Office Action Summary

10/764,071

DETAILED ACTION

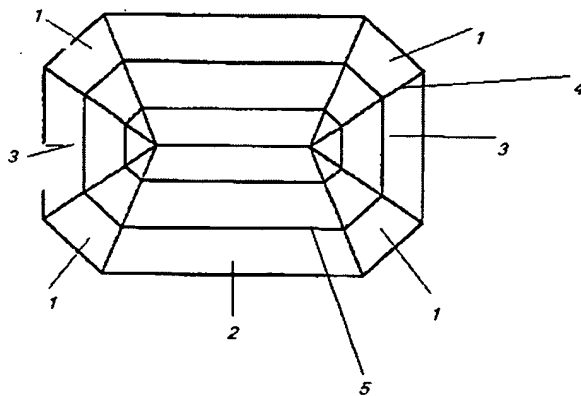
As for Claim 1, Namdar teaches of a mixed cut gemstone (see next page) comprising:

- a crown (see figures 1-4);
- a pavilion (Fig. 5);
- four lower corner facets (1), said lower corner facets being triangles (1);
- two long-side lower girdle facets (2), said long-side lower girdle facets being triangles or trapezoids (2);
- two short-side lower girdle facets (3), said short-side lower girdle facets being triangles (3);
- a plurality of step cuts (5), said step cuts being substantially equal in width; and
- a plurality of rib lines (4);

whereby said steps cuts (5) are cut at a predetermined angle with respect to said lower girdle facets (2,3) with each step (5) being at a slightly different angle, said different angle step

cuts (5) [allowing light that passes through the crown to hit the plurality of steps cuts at different angles thereby bending the light several times in different directions thus providing the gemstone with parallel incoming and outgoing rays of light that make the gemstone appear more brilliant and scintillated].
